**Re: Addendum No. 5  
Coffee Creek WWTP Improvements  
Ashtabula County Board of Commissioners**

Date: January 8, 2024

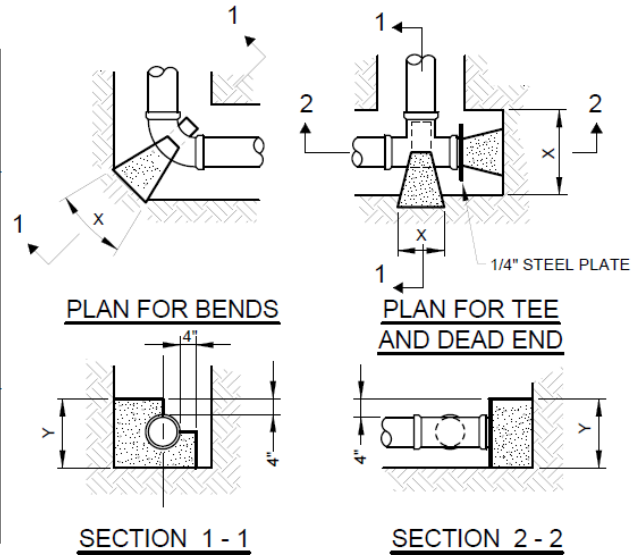
Q1. Asphalt paving was added, but not elevations and grades. I also did not see any details on cutting the grass areas and adding compacted stone.

**A1. New pavement shall generally meet the existing finished grade elevations. Assume entire new pavement will require cut to accommodate the new pavement and subbase materials.**

**THRUST BLOCKING DETAIL**

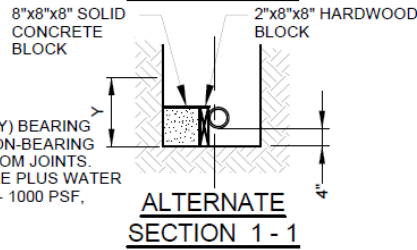
Q2. For 8 SDR26 pressure pipe FM, can you confirm what type of fittings are required?

**A2. Provide gasket push on fittings, ASTM D2241, with thrust blocks per detail. For 4” pipes not in the table use these block areas in SF.:**

Bend Angle	Assume 1000 psf
22.5 Degr	2
45 Degr	3
90 Degr	5
Tee or Dead End	4

ALL CONCRETE BLOCKING MUST HAVE ITS ENTIRE FACE (X & Y) BEARING  
 SURFACE AGAINST UNDISTURBED SOIL AND ALL VERTICAL NON-BEARING  
 SURFACES SHALL BE FORMED SO AS TO KEEP CONCRETE FROM JOINTS.  
 BLOCKING DESIGN BASED ON COMBINED WORKING PRESSURE PLUS WATER  
 HAMMER OF 240 PSI AND FOR BEARING CAPACITY FOR SAND - 1000 PSF,  
 SAND AND GRAVEL - 3000 PSF, SHALE - 5000 PSF.

**OUTER PIERS**

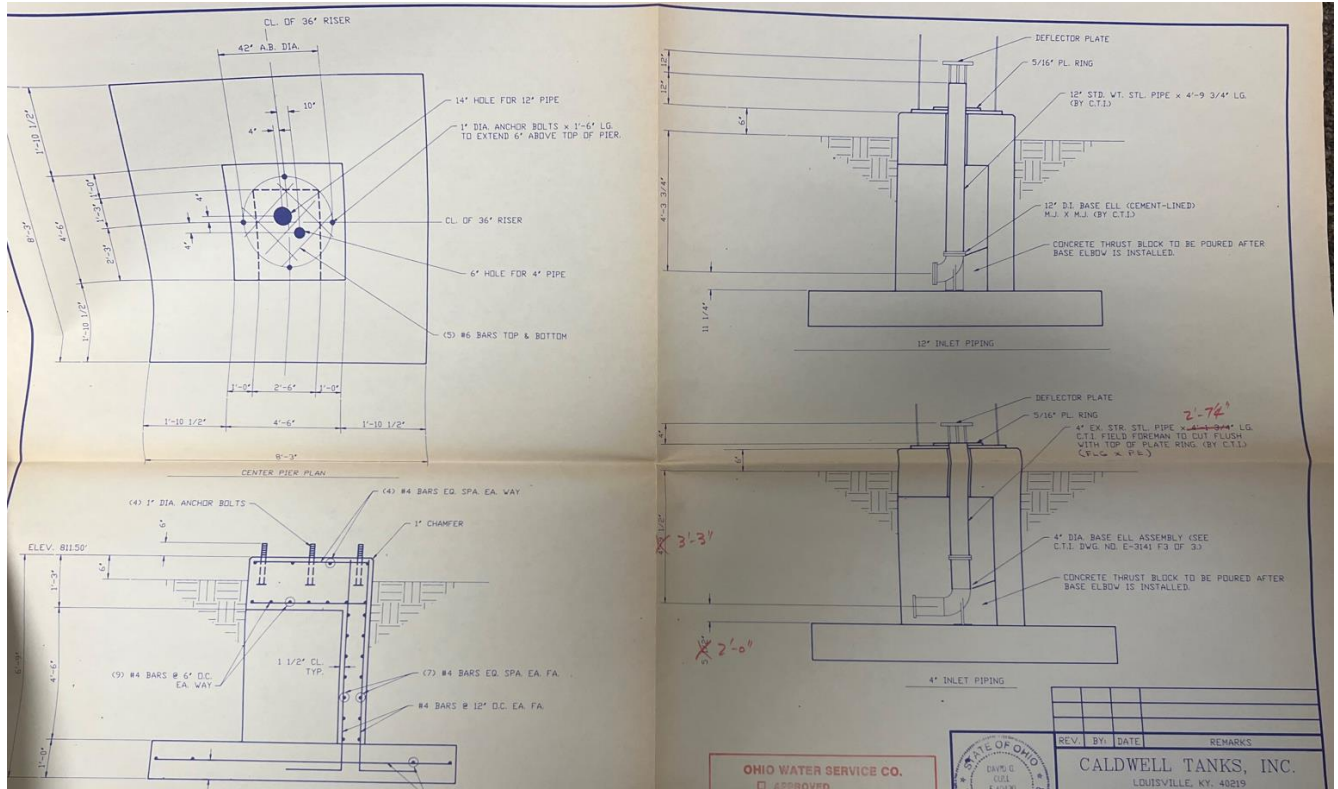
Q3. Can you provide us with details on the water tank foundation? We need the information to quote the retention system for the head works building. If not, please provide the design or an allowance for the retention system.

**A3. Below are the original tank drawings for the Outer Piers and Center Pier from Caldwell Tanks.**
